SUBJECT: **Customer Satisfaction Program 21N01 - Supplement #1**
 Certain 2016-2018 Model Year Explorer Vehicles
 High-Speed Cooling Fan Motor Relay

REF: **Customer Satisfaction Program 21N01**
 Dated: August 19, 2021

New! REASON FOR THIS SUPPLEMENT

FIGURE 1

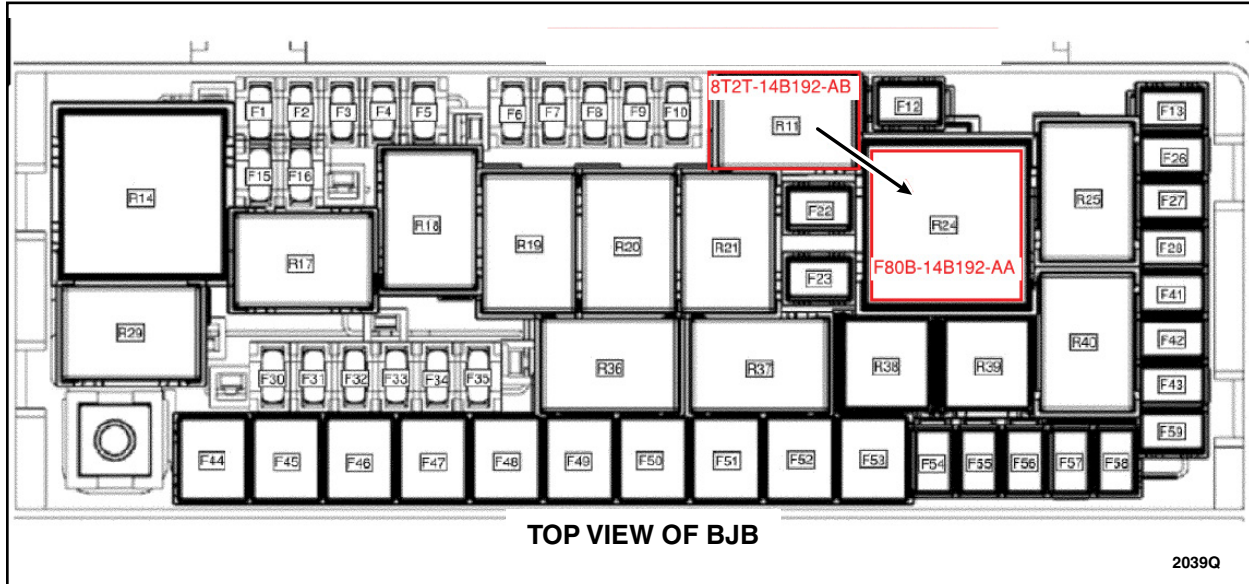
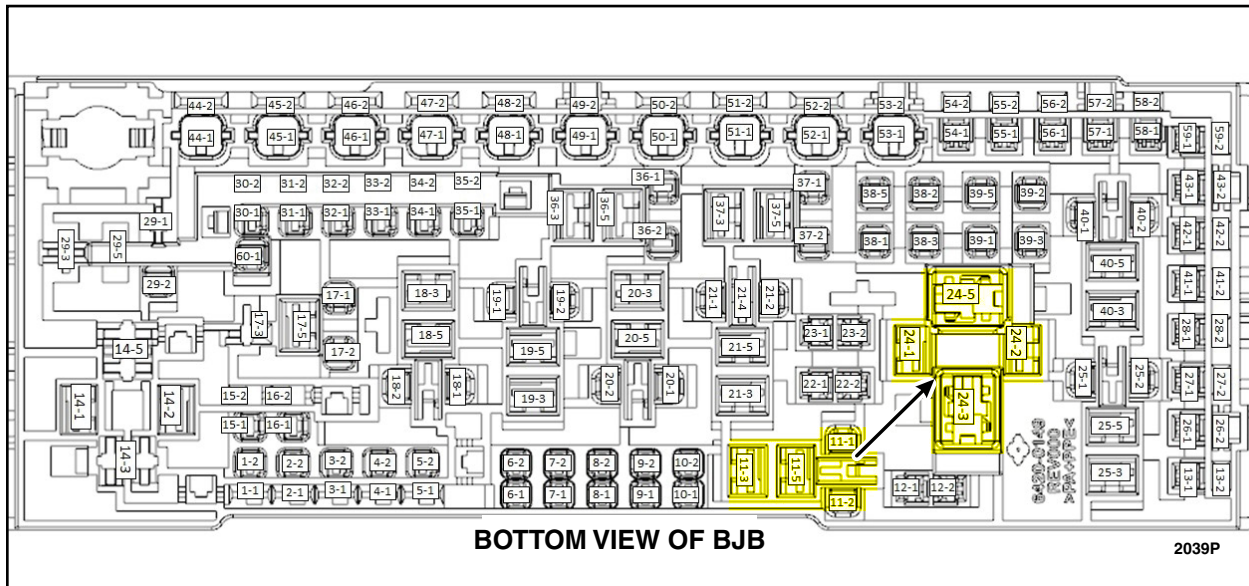
NOTE: The high speed cooling fan relay (R11) will be relocated to the (R24) position in the Battery Junction Box (BJB) as shown in Figures 1 and 2.

FIGURE 14

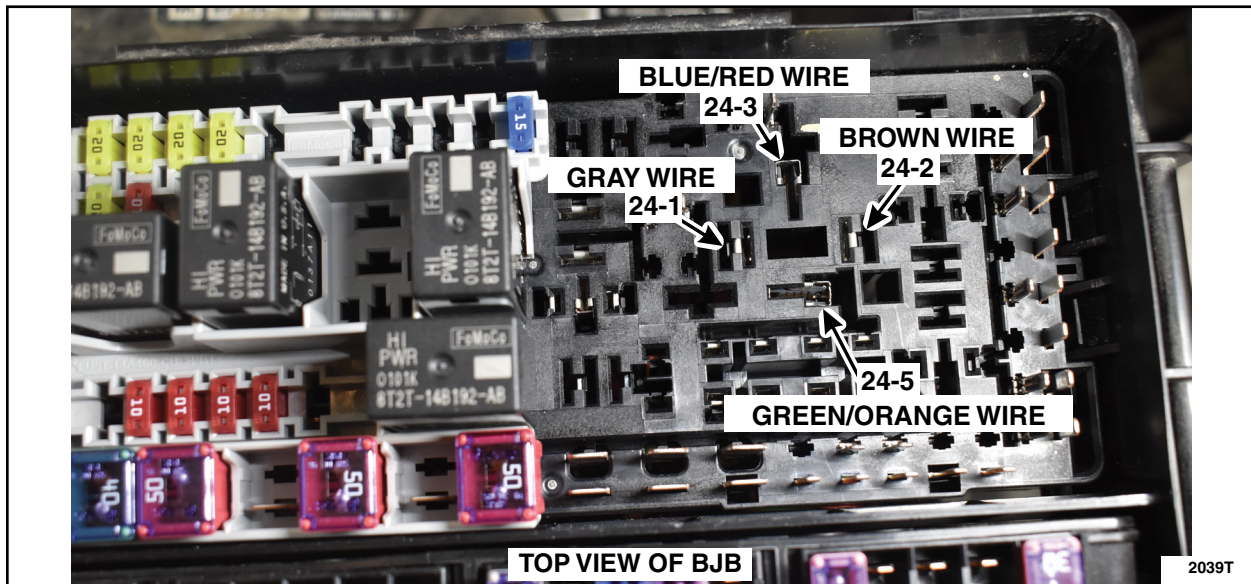
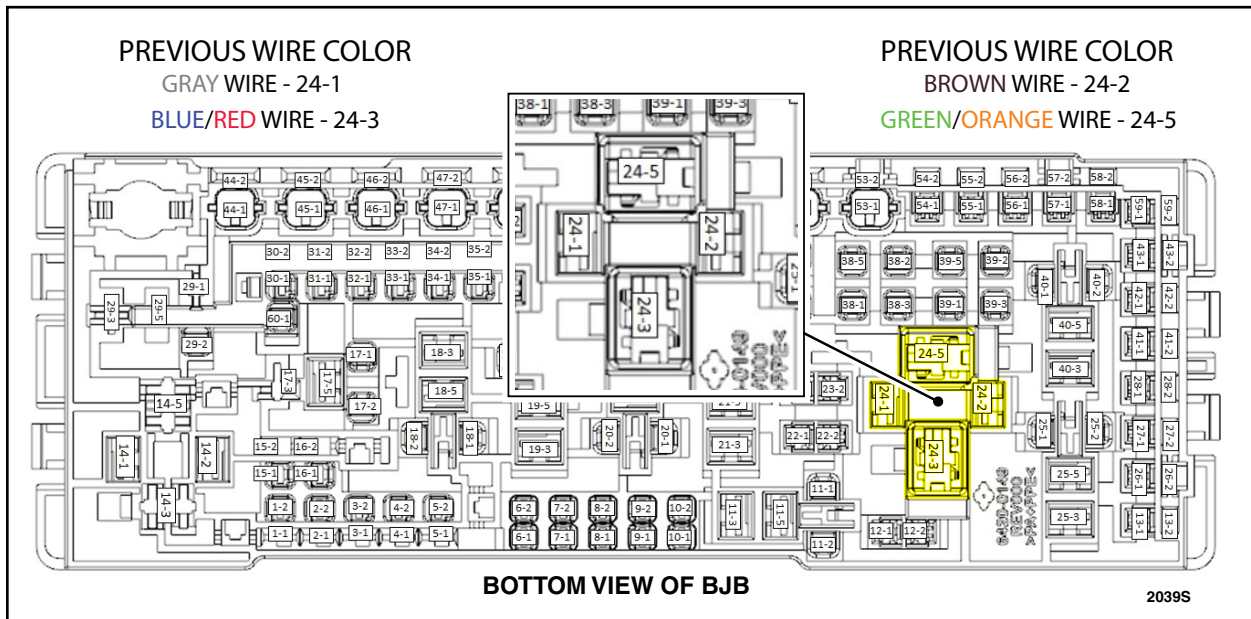
10. Install the four (4) wires, removed from the original relay with *new* terminal ends, into the *new* relay R24 cavities as noted below. See Figures 14 and 15.

- Install what was the original gray wire into cavity 24-1.
- Install what was the original brown wire into cavity 24-2.
- Install what was the original blue/red wire into cavity 24-3.
- Install what was the original green/orange wire into cavity 24-5.

FIGURE 16

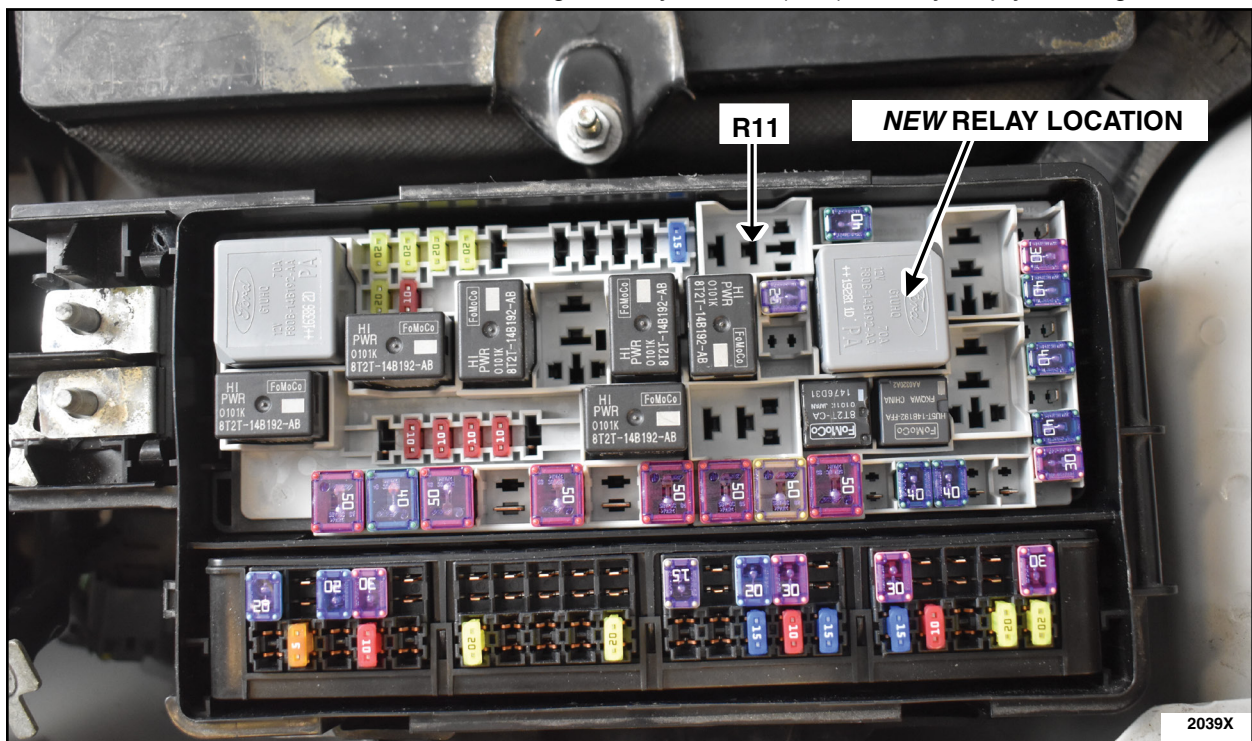
11. Position all wiring into the lower BJB half. Then, align the upper BJB half with the lower BJB half. Push straight down to seat the clips on the side. Audible clicks can be heard as the clips correctly seat.
12. Reinstall the TPA plastic lock by aligning all of the male terminals in the BJB with the TPA lock and gently push straight down. As the TPA is installed, it can be felt as it passes by the lobes and properly seats. See Figure 6.
 - Inspect all four (4) corners of the TPA insert to ensure it is flush with the BJB housing.
13. Install the *new* larger high speed cooling fan relay into the new location, R24. See Figures 1 and 16.
14. Install the remaining fuses and relays with the exception of the original cooling fan relay R11 location, which should have been discarded. The original relay location (R11) will stay empty. See Figure 16.
